CHABOT-LAS POSITAS
COMMUNITY COLLEGE DISTRICT
PURCHASING DEPARTMENT

Addendum No. 1
INVITATION TO BID No.: B19/20 - 18
DW Emergency Call Station (ECS) Project

This Addendum One (1) is issued to incorporate the following changes, additions or deletions to the Bid No. B19/20-18. Any modifications/changes made by this addendum affect only the portions or paragraphs specifically identified herein; all remaining portions of Bid No.B19/20-18 to remain in force. It is the responsibility of all responders to conform to this addendum.

SHEET
T5
OF 85 SHEETS

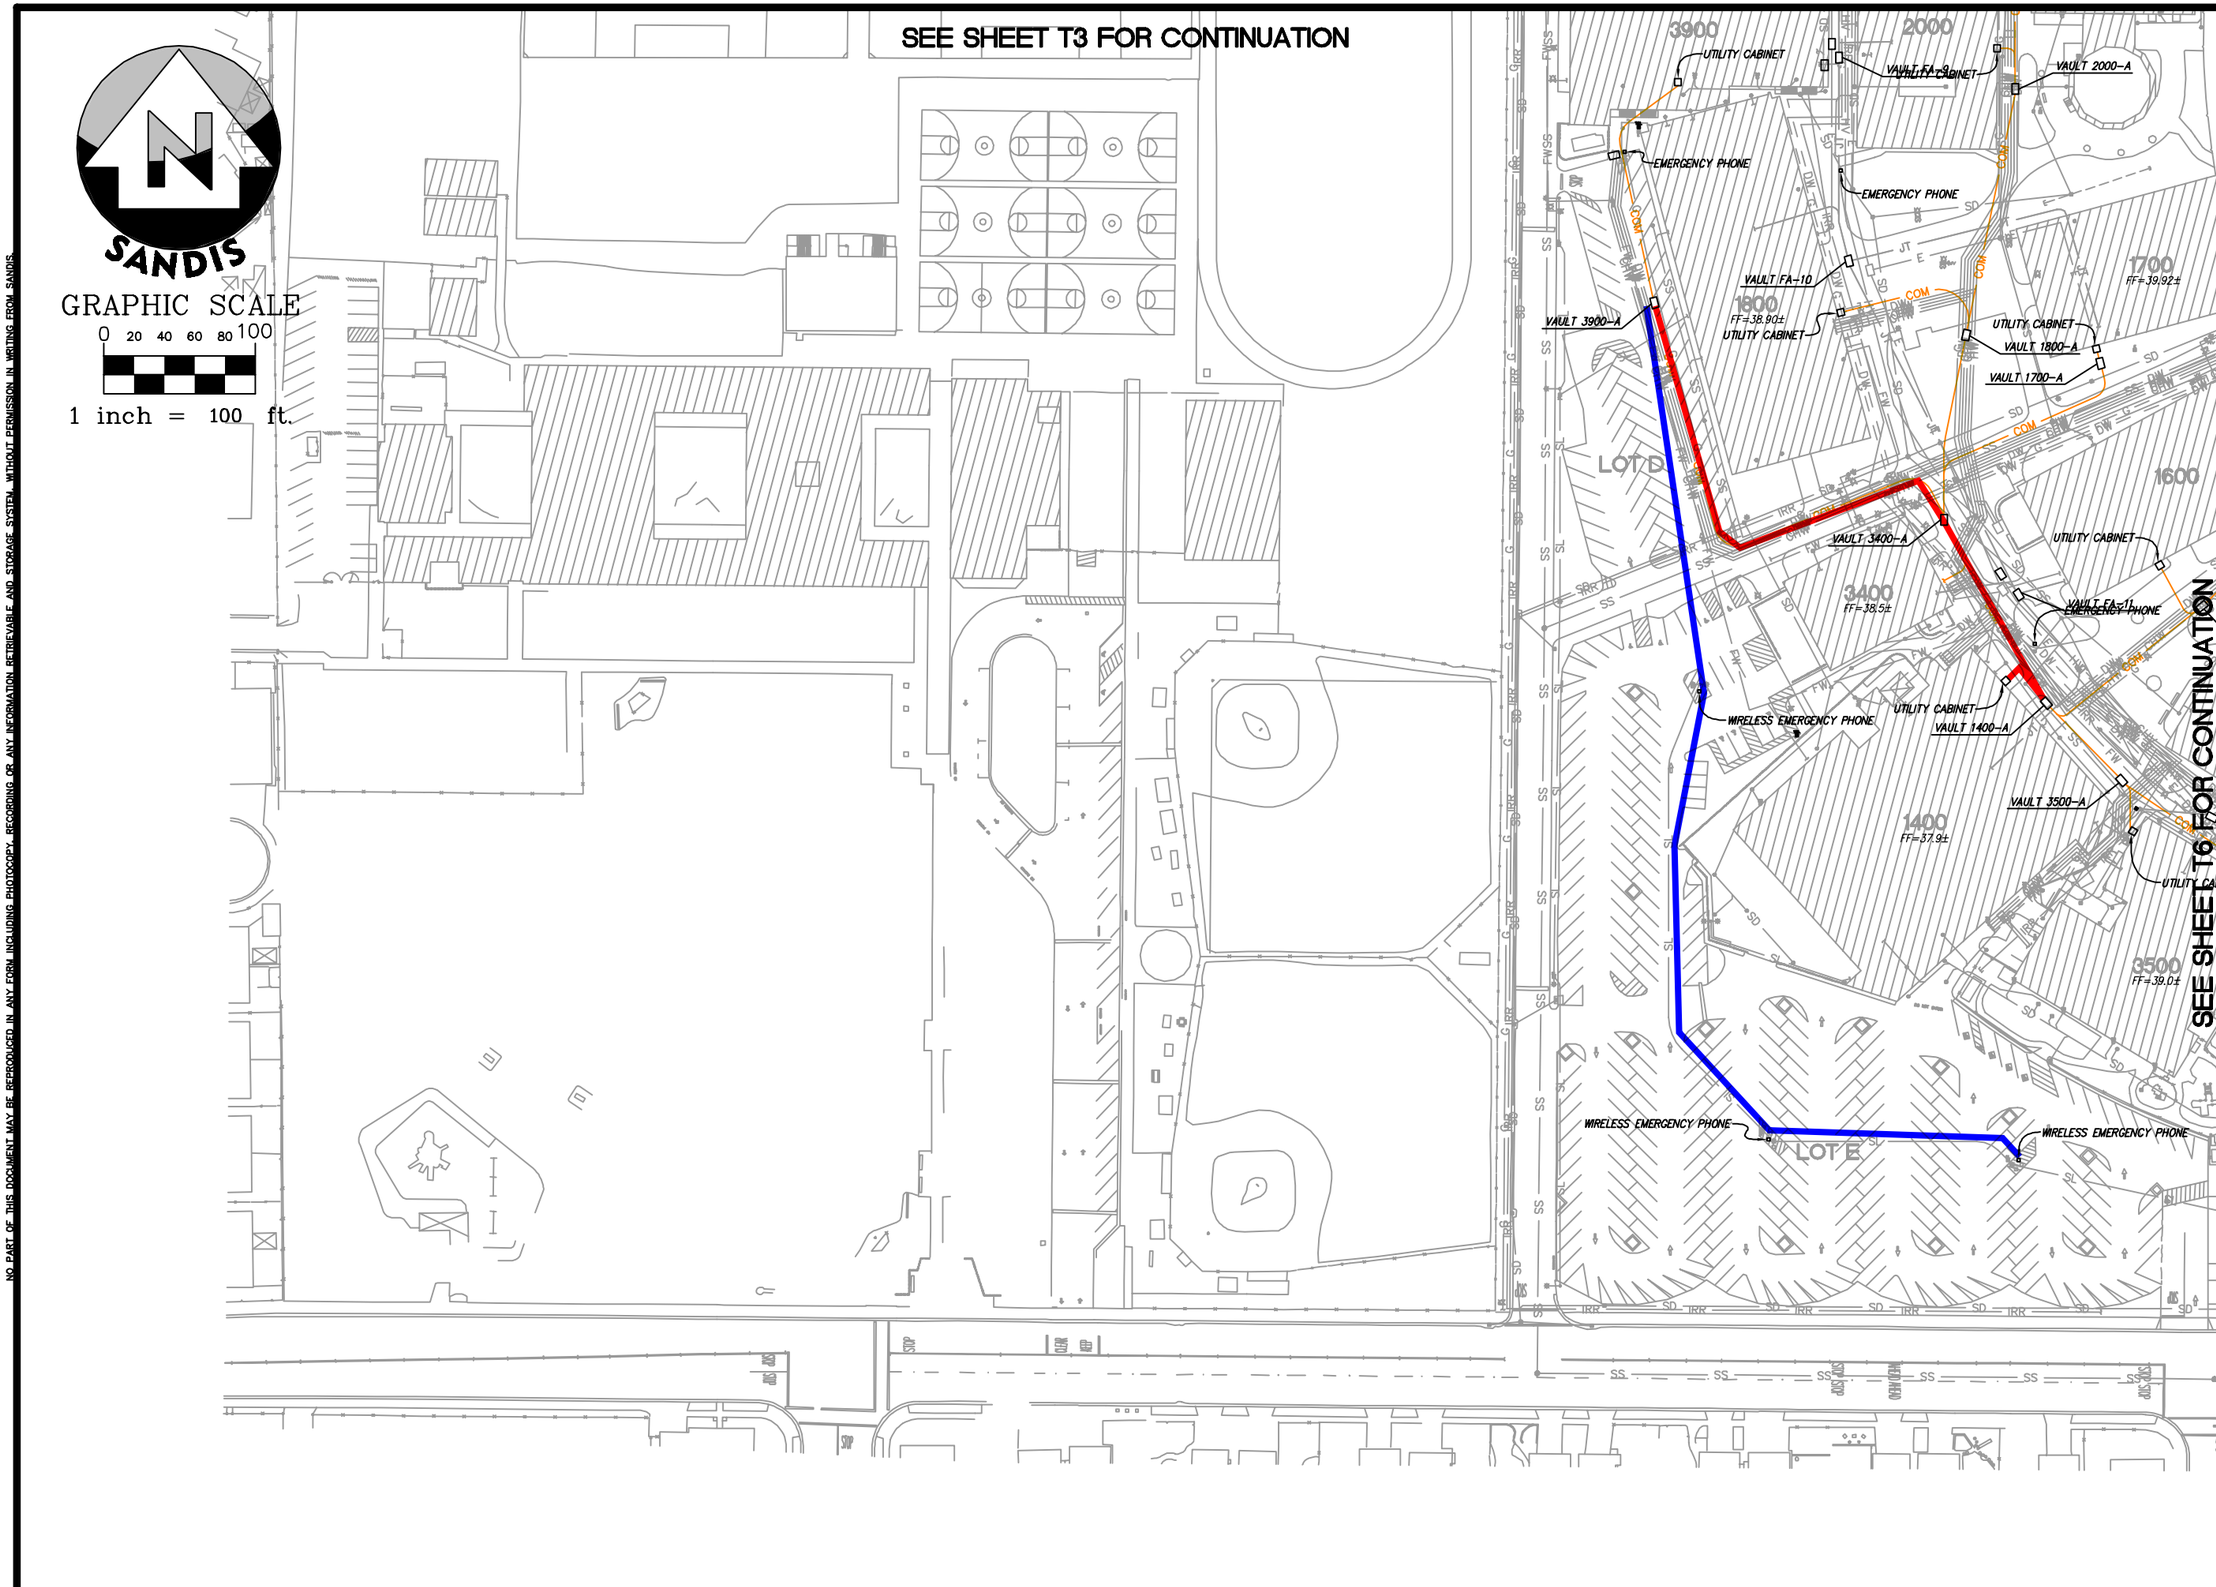
Response: The suggested trenching/ boring route for the 3 units on the Chabot Campus are highlighted on page 10 (Sheet T5) of Attachment A – Chabot College Utility System Map Excerpts from Sandis dated August 2014 - Rev 1. The blue highlight indicates the suggested trenching/boring route and the red highlight indicates the existing utility infrastructure into the IDF in B1400.
